APPLICATION NO: 18/2017/0652/ PF

PROPOSAL: Alterations to existing vehicular access and replacement boundary wall

LOCATION: Glan Y Wern Lodge Whitchurch Road Llandyrnog Denbigh

Drawing title
Proposed Site Layout Plan.

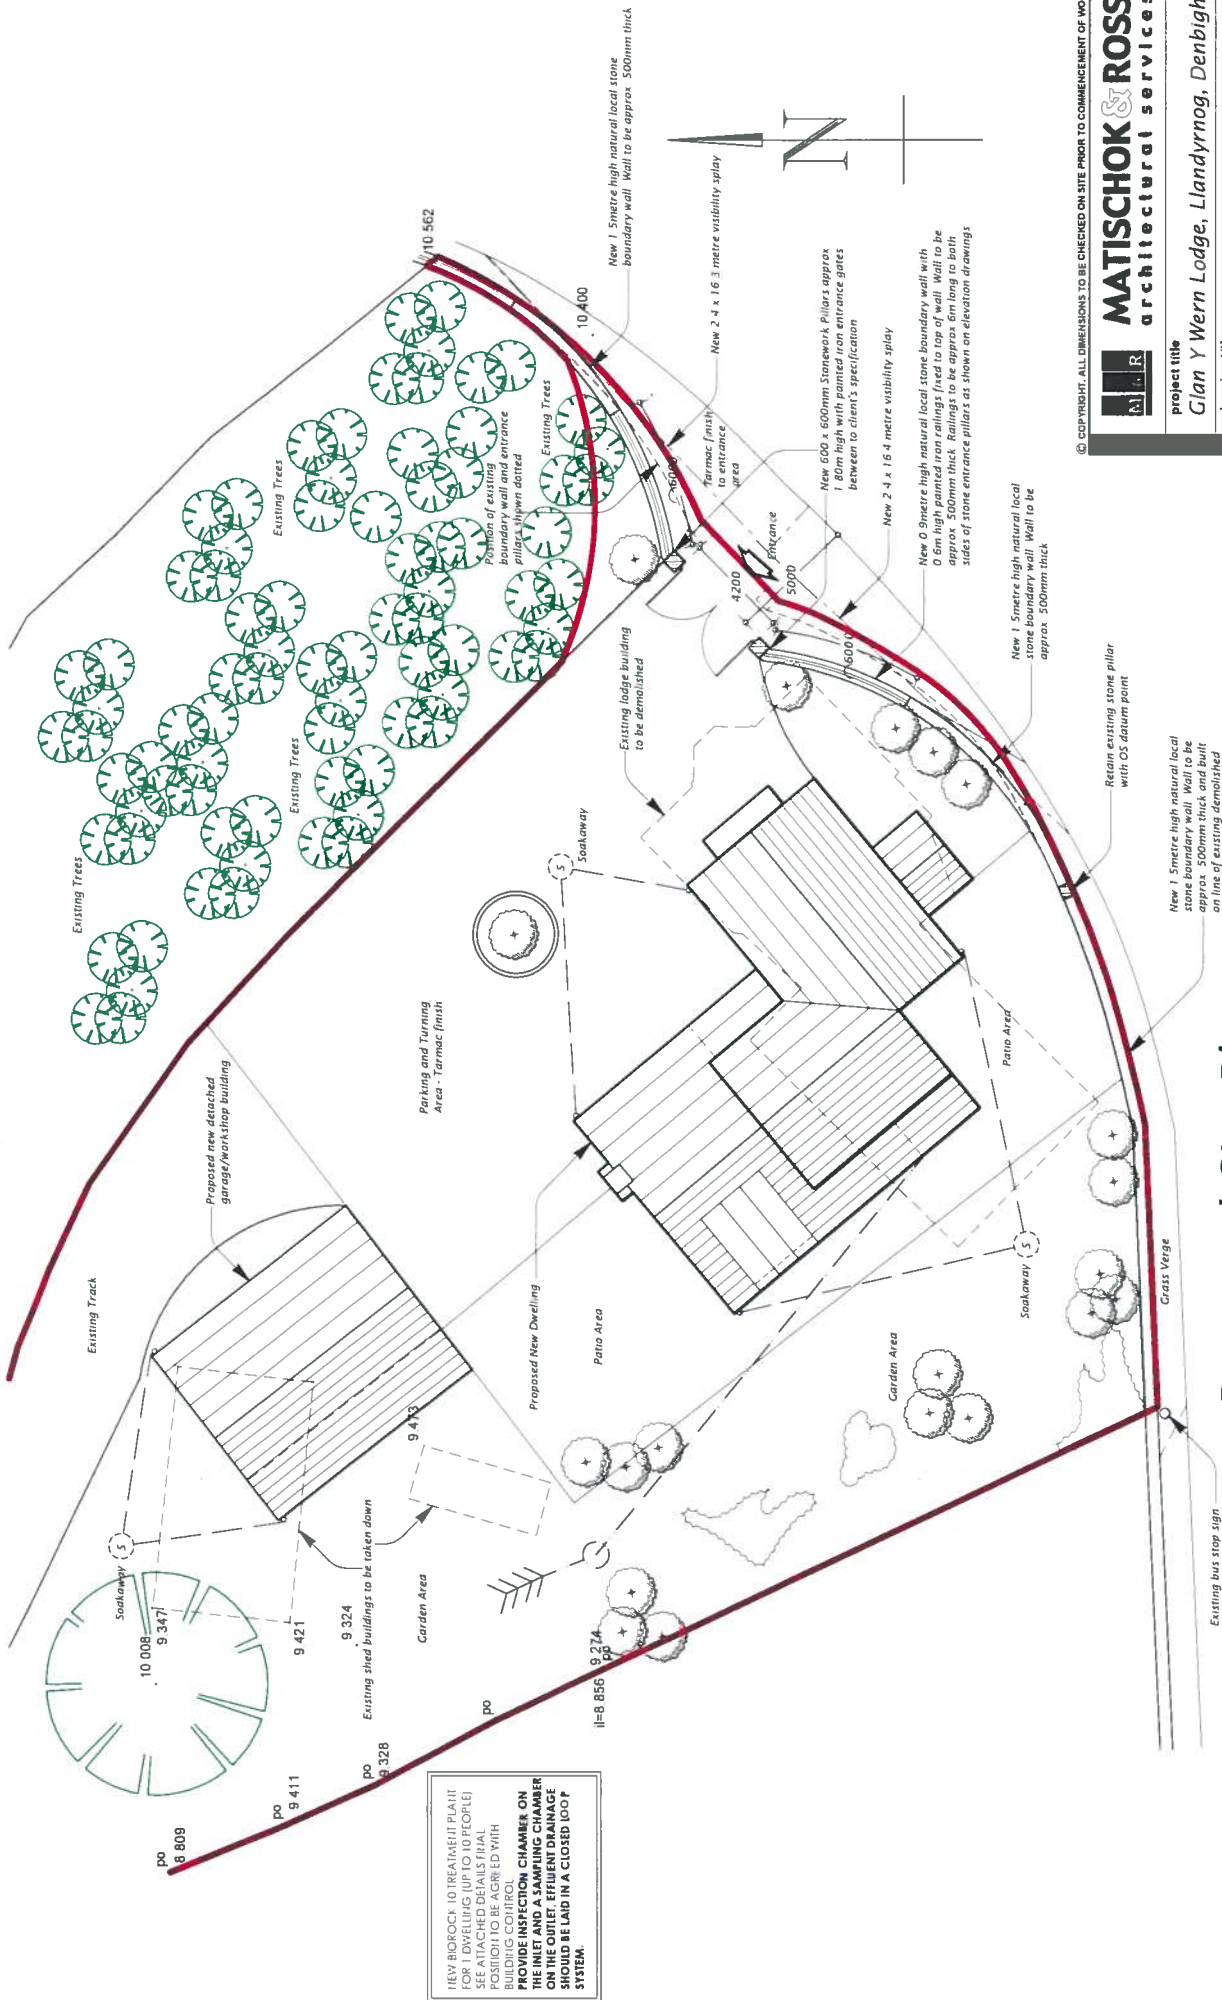
“There is an existing vehicular access to the Lodge and this should be seen as an opportunity to improve the access however although the gate is set further back from the side of the road the visibility to other road users has been made worse by raising the stone wall to 1.5m. CC kindly asks that the stone wall be reduced to 900mm and capped with railings along whole length not first 6m visibility splay - confirmation will be required from Highways that the standard visibility splay for 40mph has been achieved or why do they feel a compromise is acceptable?”

The bus stop on the eastern boundary has not been shown this needs to be taken into consideration.

The gates as shown are too ostentatious and should reflect the fact that this is a Lodge and be reduced in width to the current width circa 3m - they need toning down drastically.”

The Community Council has raised concerns on highways safety grounds and has requested confirmation that the standard visibility splay for 40mph have been achieved, and if not, why a compromise is acceptable. They also consider the proposed 0.9m high stone wall capped with railings should be installed for the whole length of the boundary and not just the first 6m visibility splay on highway safety grounds; and they consider raising the height of the stone wall to a 1.5m high wall would reduce visibility for other road users approaching the roundabout junction.

- 1.5.1 Revised plans have been submitted in response to the initial Community Council and Highway Officer responses. These add the visibility sight lines, confirming the proposals would marginally increase the visibility available to drivers of vehicles exiting the site onto the roundabout.

Following the submission of amended plans, the Highway Officer has advised the proposal represents an improvement to the existing arrangements and is deemed acceptable.

Factually, the proposal is to set back the access 1.5m further into the site, to widen the access from 2m to 4.2m and to increase the visibility splay to 2.4m by 16.4m and 16.3m (from 2.4m by 13.2m and 14.7).

In respect of the Community Council's reference to visibility standards, it is not considered appropriate to apply the TAN18 Annex B recommended Visibility Standards, which are relevant considerations for new accesses to *new* developments. This is a site with an existing dwelling served by an existing vehicular access onto a roundabout, which the Council has already deemed acceptable to serve a replacement dwelling. As the proposed alterations to the access consist of widening the access, setting the gates further back into the site by some 1.5m and realigning the frontage walls to improve visibility at the point of entry onto the roundabout, the proposal would be an improvement to the existing access arrangements and is deemed worthy of support on those grounds.

In noting the Community Council's comments in relation to the detailed boundary treatment, it needs to be recorded that the existing boundary is formed by a mix of high and low stone walls, fencing, railing and a hedge. The existing stone wall along the Whitchurch Road boundary is a high wall which the plans indicate is 1.8m in height. Whilst there is a low level stone wall on the curved boundary adjacent to the round about junction, there are existing railings / wooden fencing immediately behind the low level wall which the plans indicate are also 1.8m in height. The new stone wall proposed around the boundary with the highway would have a height of 1.5m, and as such Officers do not consider the effect of the proposal would be to reduce visibility of other road users, nor would it be reasonable to require the height of the wall to be reduced to 0.9m along the full boundary on highway safety grounds given that the existing boundary treatments have a height of 1.8m.

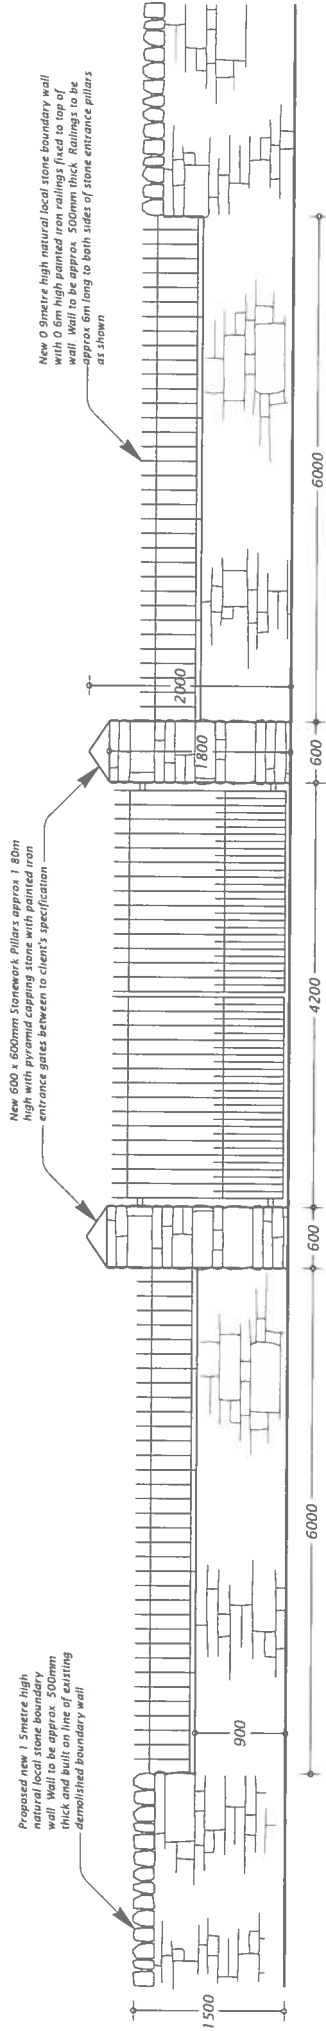
The Community Council consider the gates as shown are too ostentatious and should reflect the fact that this is a Lodge and be reduced in width and 'toned down'.

In respecting the basis of the Community Council's concerns, it is of relevance that whilst the existing dwelling is a traditional lodge building, the replacement dwelling consented in 2015 is a large modern two storey dwelling with a large detached garage, and in the context of this detailing, the revised access, frontage wall and gate detailing is not considered to be out of keeping with the dwelling itself.

Additionally, the site is not within a designated landscape area and it is not an isolated site in open countryside as it forms part of a ribbon of properties clustered around the road about junction to the north of Llandyrnog village which vary in scale and design with a mix of differing boundary and entrance treatments. The site is also close to the Llandyrnog Creamery complex. Officers therefore do not consider the site is in a particularly sensitive setting, and as such the proposed replacement wall and alterations to the access are not considered likely to give rise to an unacceptable impact on the visual amenity of the area.
